# SERVICE BULLETIN ML 0010

Date : 31 August 1999  
Game : Happy Hobos  
Subject : Excessive Guiding Ring Wear

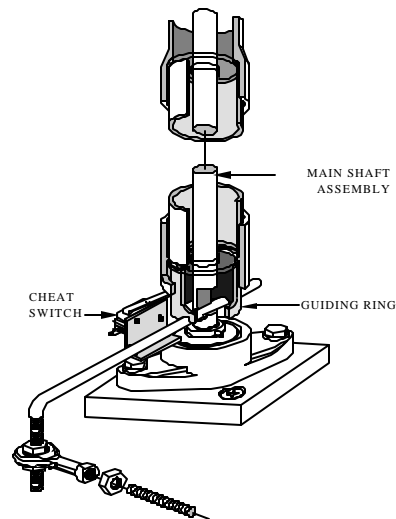
: Prolonged Activation of the Cheat Detection Mechanism is resulting in excessive wearing to the Guiding Ring and Main Shaft Assembly. This is resulting in the Cheat Switch not activating and also in the collapse of the Movement Mechanism

: A new Guiding Ring of Nylon to replace the original Iron Guiding Ring are now available at your closest LAI Games Distributor.

Check the Serial Number Plate of your machine. Machines with a LAI Plate must use the Nylon Guiding Ring with a diameter of 56mm and those with a ML plate will use the Nylon Guiding Ring with a diameter of 60mm

Mark the location of the notch in the old Guiding Ring on the Plastic Pipe. Remove the Head Stop bracket and slide the Head Assembly out of the machine. Remove the retaining screw and old Guiding Ring, you may have to heat the pipe to help loosen it.

Insert the New Nylon Guiding Ring and align the notch with the mark you made on the plastic pipe. Drill a small pilot hole at the retaining screw hole and fit a self-tapping screw. It may be advisable to place a second retaining screw 90 degrees from the first.
